# CRITICAL INSTRUCTIONS

Application: Renault Master/Vauxhall Biturbo 2.3LD

Part Number:

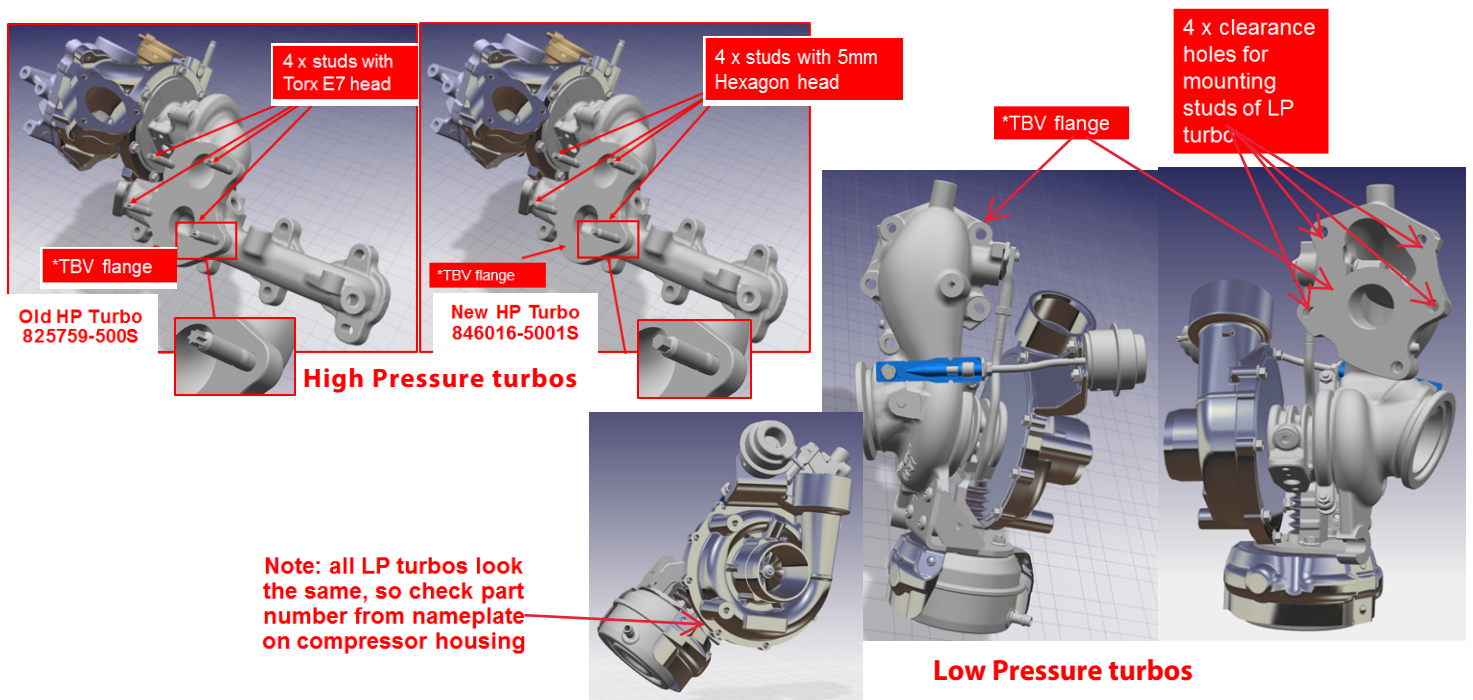
When installing the replacement High Pressure (HP) and Low Pressure (LP) turbos on the Renault TwoStage Series Turbos, it is critical that the correct studs are fitted. If the wrong combination of stud material and turbine housing is used, there is a high risk of the joint between the turbos loosening with consequent exhaust gas leakage.

During the production life of these turbos, the material used for the turbine housing of the Low Pressure turbo changed. At the same time, the material of the mounting studs fitted in the High Pressure turbo changed.

If only replacing 1 of the 2 stages then the new stud and gasket kit will need to be purchased from BTN, part number - 887588-0001

**If replacing both the Low Pressure and High Pressure turbos, part numbers 825758-5003S/5004S & 825759-5002S - no change of studs is required and no kit is required - use replacement turbos 883860-5001S for Low Pressure and 846016-5001S for High Pressure.**

Different head shape indicates different material

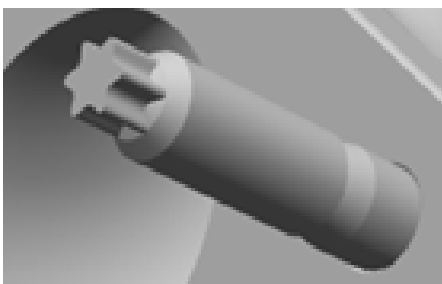
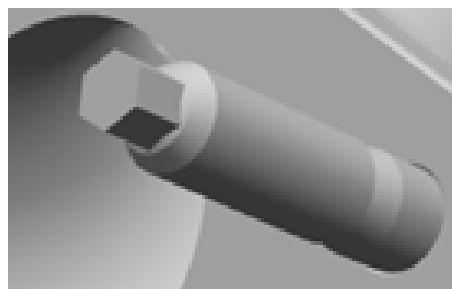
- **If replacing both old LP turbo 825758-5003S (or -5004S) and old HP turbo 825759-5002S** Use new LP turbo 883860-5001S, which includes a new TBV gasket.  
Use new HP turbo 846016-5001S, which has the correct hexagon head studs already assembled on the TBV flange.

**No change of studs – no kit needed**
- **If replacing only the old LP turbo 825758-5003S (or -5004S)**  
Use the x4 Torx headed studs in the flange of the existing High pressure turbo and replace them with the x4 Hexagon head studs from the kit before fitting the replacement Low pressure turbo. Tighten the studs to 12.0 - 17.0Nm

**Stud and gasket kit required - 887588-0001 - available from BTN**
- **If replacing only the old LP turbo 846015-5001S and keeping existing HP turbo 846016-5001S**  
Use new LP turbo 883860-5001S which includes a new TBV gasket. Although the HP turbo 846016-5001S is already fitted with the correct Hexagon head studs, in all cases it is better to change them for the new Hexagon head studs from the kit. Tighten studs to 12.0 – 17.0Nm

**Stud and gasket kit required - 887588-0001 - available from BTN**
- **If replacing only the old HP turbo 825759-5002S and keeping the existing LP turbo 825758-5003S (or -5004S)**  
Use new HP turbo 846016-5001S + Stud and Gasket Kit.  
Remove the x4 Hexagon head studs from the new HP turbo and replace them with x4 Torx head studs from the Stud and Gasket Kit. Tighten studs to 12.0 – 17.0Nm  
Use the new TBV gasket from the kit.

**Stud and gasket kit required - 887588-0001 - available from BTN**
